Display

Model: **BVM-D14H1U, BVM-D14H5U**

Subject: **CORRECTING HORIZONTAL STREAKING NOISE**

Figure 1

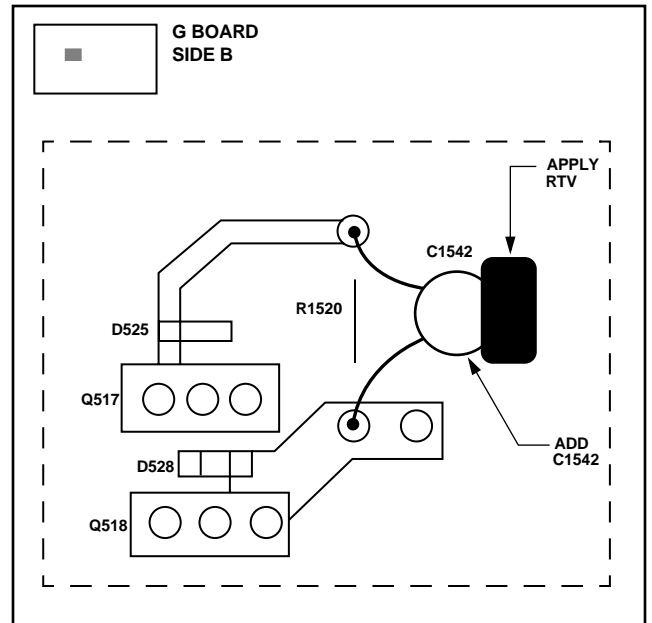
Horizontal streaking noise may appear in a dark scene, at 4:3 normal scan, due to oscillation in the V FOCUS AMP circuit.

1. Solder 330pF capacitor C1542 in parallel with resistor R1520 on G board, suffix -11 and -12 (side B, zone G-3) as shown.

2. Apply RTV to secure capacitor to G board as shown.
